DART SERVICE INSTRUCTION

TO AMEND INSTALLATION INSTRUCTIONS IIN-D119-675 REV. B AND INSTRUCTIONS FOR CONTINUED AIRWORTHINESS ICA-D119-675 REV. 2

REF. FAA STC SR00948SE & EASA STC EASA.IM.R.S.01458

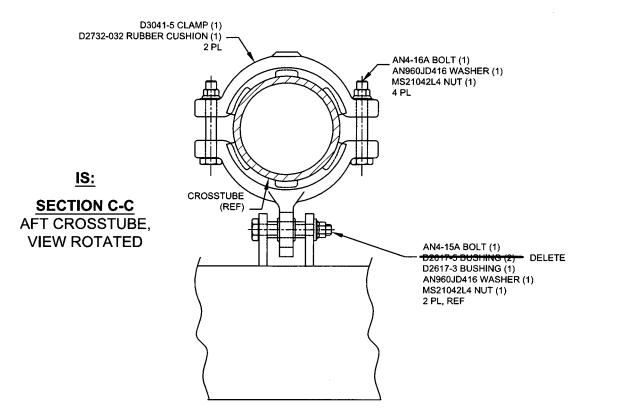
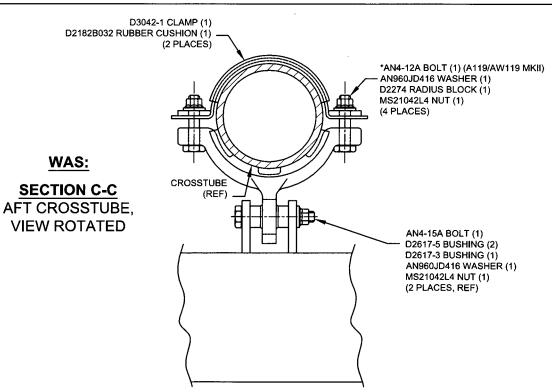
- 2.1 The DSI 9647-011 Clamp Replacement Kit can be procured from Dart. One kit upgrades one step.
- 2.2 Remove and discard the D3042-1 Clamps, D2182B032 Rubber Cushions and hardware. Replace with the D3041-5/-7 Clamps, D2732-032 Rubber Cushions and hardware as shown in Section B-B and C-C of this Service Instruction.
- 2.3 Tighten clamp bolts. Do not exceed torque of 60 in-lb (6.8 nm) on the nuts. **CAUTION:** Over-torquing the nuts could lead to structural damage of the clamps.
- 2.4 Amend weight and balance per section 4.0 of this Service Instruction.

- 3.4 Install the D2732-032 Rubber Cushions under the D3041-1/-3/-5/-7 Clamps (see Sections B-B and C-C (of this DSI)).
- 3.5 Find the appropriate step height by locating the step/clamp as shown in View A-A. Locate the forward D3041-1/-3 Clamp 7.8"- 10.4" above the crosstube cuff. Locate the aft D3041-1 Clamp 7.8"-11.6" above the crosstube cuff. The distances given are from the crosstube cuff to the bottom-most clamp.
